Well Name	Well Number	US Well Number	Lease Number	Case Number	Operator
TAILS CC 10_3	35H	3001548965	NMNM081616	NMNM081616	OXY USA
TAILS CC 10_3	31H	3001548881	NMNM81616	NMNM81616	OXY USA
TAILS CC 10_3	32H	3001548880	NMNM81616	NMNM81616	OXY USA
TAILS CC 10_3	36H	3001548964	NMNM081616	NMNM081616	OXY USA
TAILS CC 10_3	312H	3001548930	NMNM81616	NMNM81616	OXY USA
TAILS CC 10_3	33H	3001548879	NMNM81616	NMNM81616	OXY USA
TAILS CC 10_3	38H	3001548877	NMNM81616	NMNM81616	OXY USA
TAILS CC 10_3	34H	3001548959	NMNM081616	NMNM081616	OXY USA

Notice of Intent

Type of Action: APD Change

CAMERON ADAPT WELLHEAD - NM

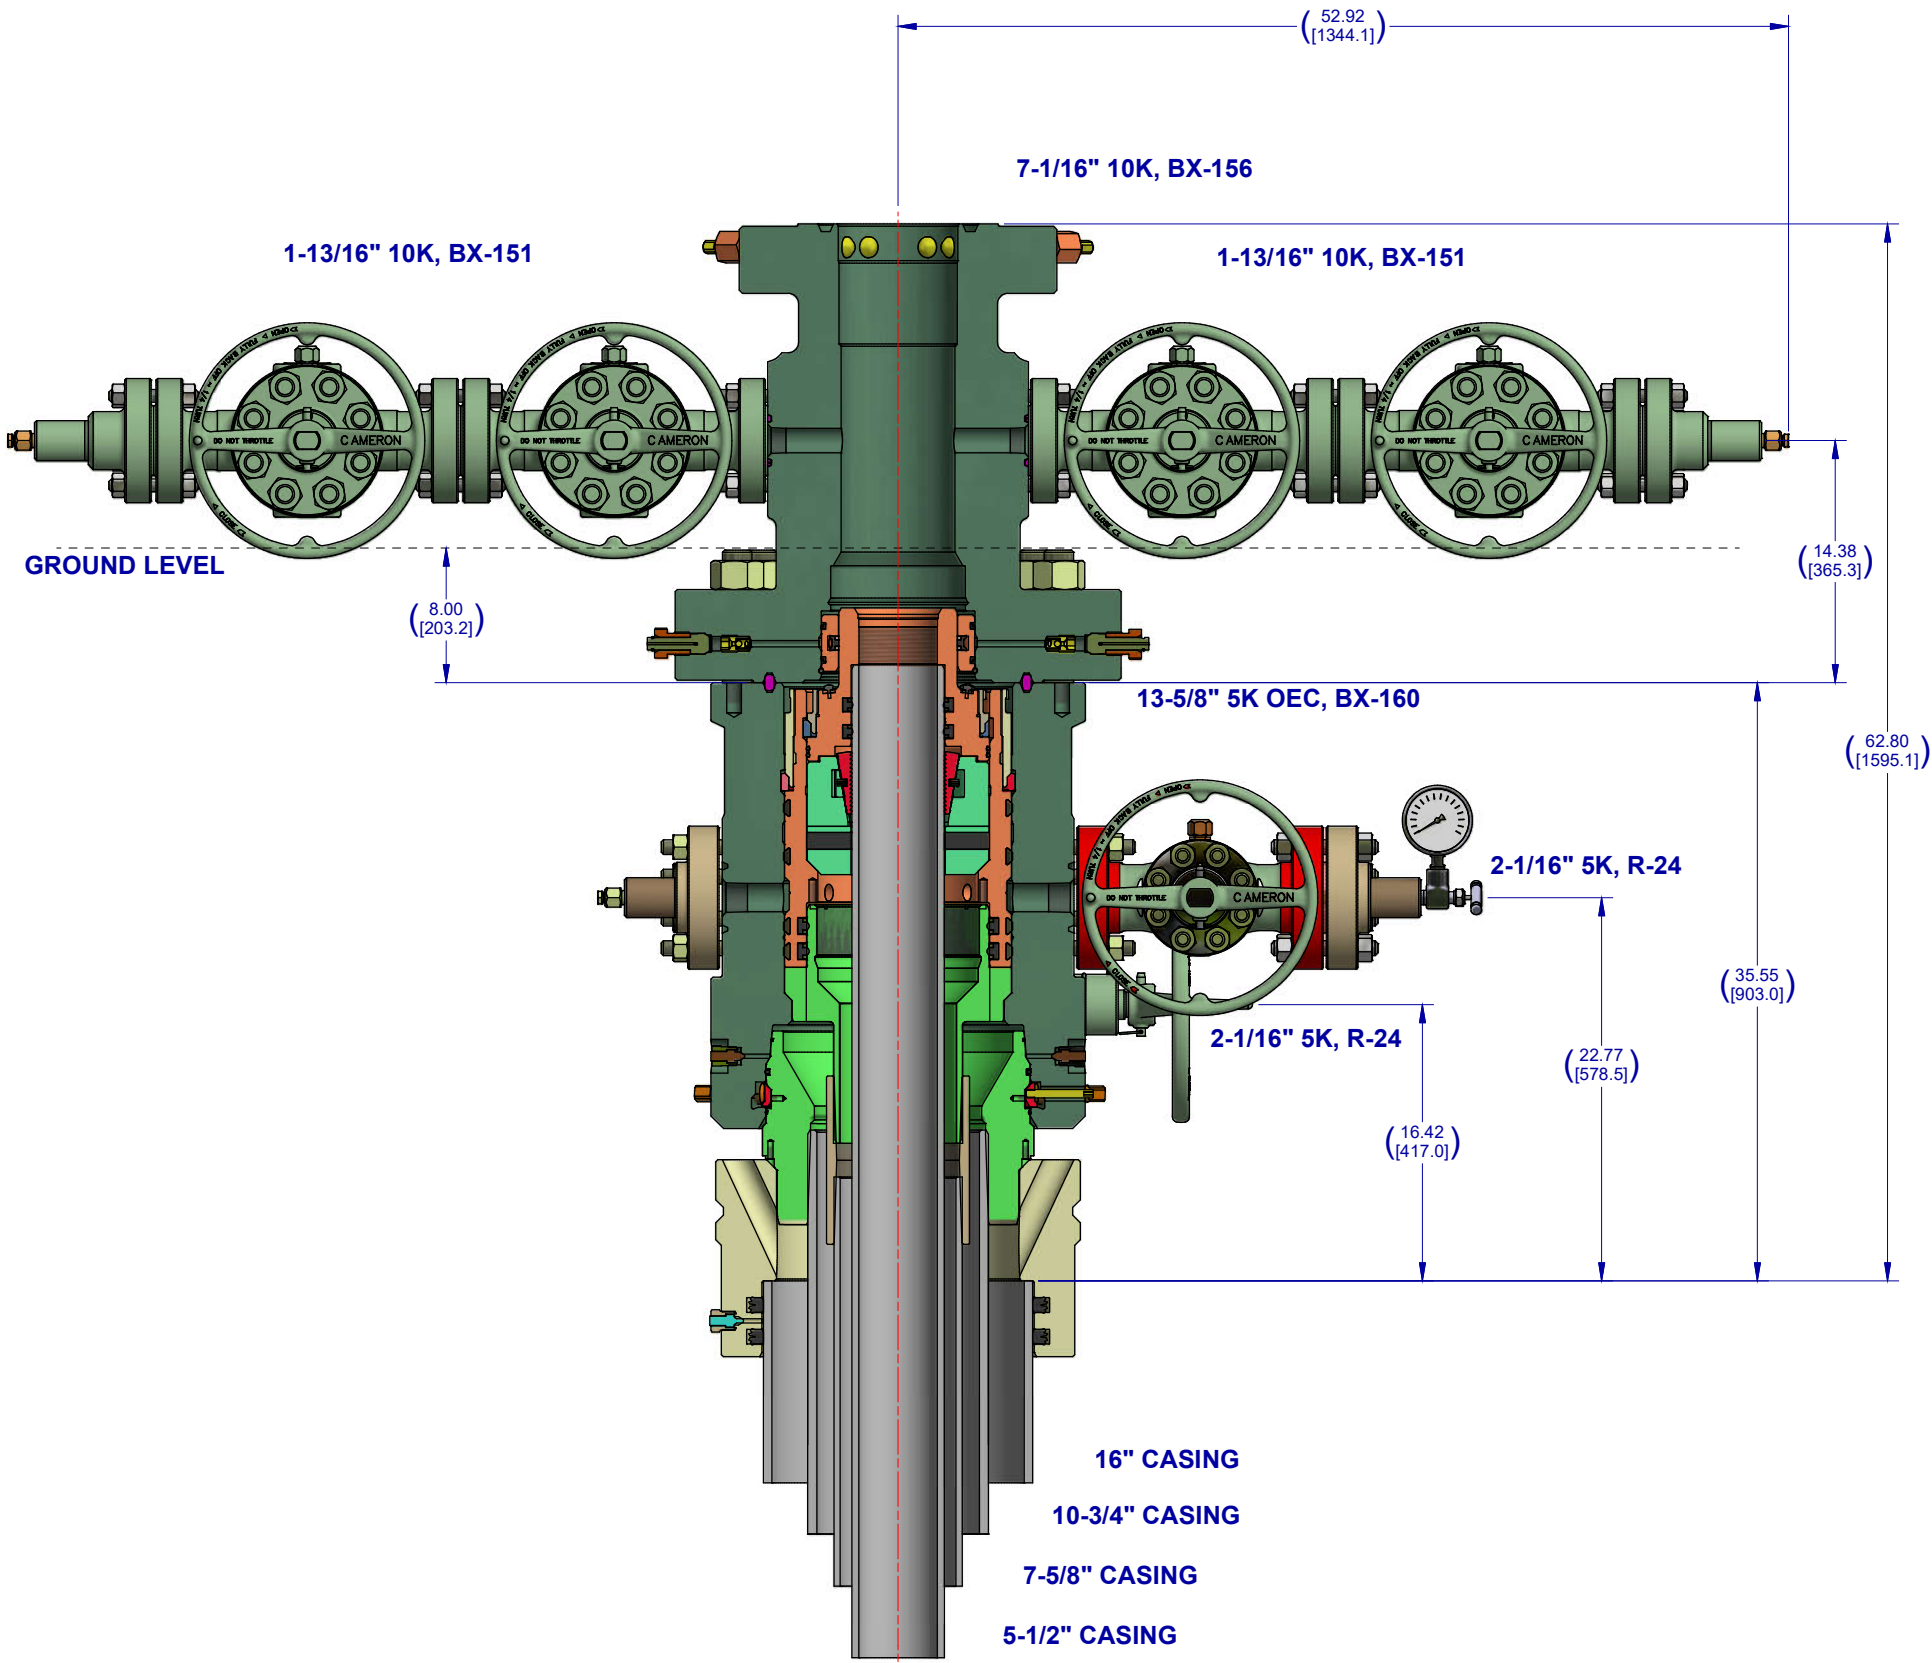
Procedure Description: OXY USA Inc. respectfully requests approval to amend the subject well AAPD wellhead design. See the attached diagram of the planning wellhead system for the Tails wells. The drilling rigs are currently moving onto the well pads to being drilling. OXY will use Cameron ADAPT wellhead system that uses an OEC top flange connection. This connection has been fully vetted and verified by API to Spec 6A and carries an API monogram. See the attached wellhead slide.

- All Wellhead Components have API monogram
 - Casing Bodies, Hangers, Tubing Spools, Valves, Slips, Ring Gaskets
 - Packoffs are not monogrammed per API
- Top connection of ADAPT casing head is not an API flange (classified as other end connector aka “OEC”),
 - Uses standard API ring gasket and has been certified and vetted by API
- R-type ring gaskets on casing head outlet valves
 - You could run RX if you wanted to
- BX-type ring gaskets for tubing spool + outlet valves
